11th Aug, 2020

Notification for copper ring free (Removal) for DC solenoid valve

DC voltage solenoid valve:

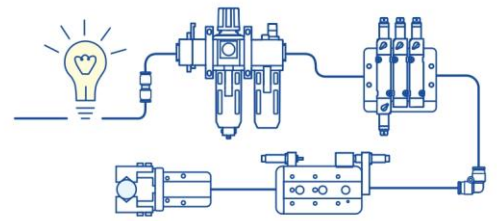
Due to process change, kindly be notified that copper ring of DC solenoid valve will no longer be used onward.

Before	After	
Appearance	<p style="text-align: center;">DC/AC assembly tube</p>  	<p style="text-align: center;">DC assembly tube</p> 	<p style="text-align: center;">AC assembly tube</p> 
Note	<p>Assembly tube can be adapted in both DC & AC solenoid valve.</p>		<p>The AC and DC coils of the solenoid valve cannot be used interchangeably.</p>
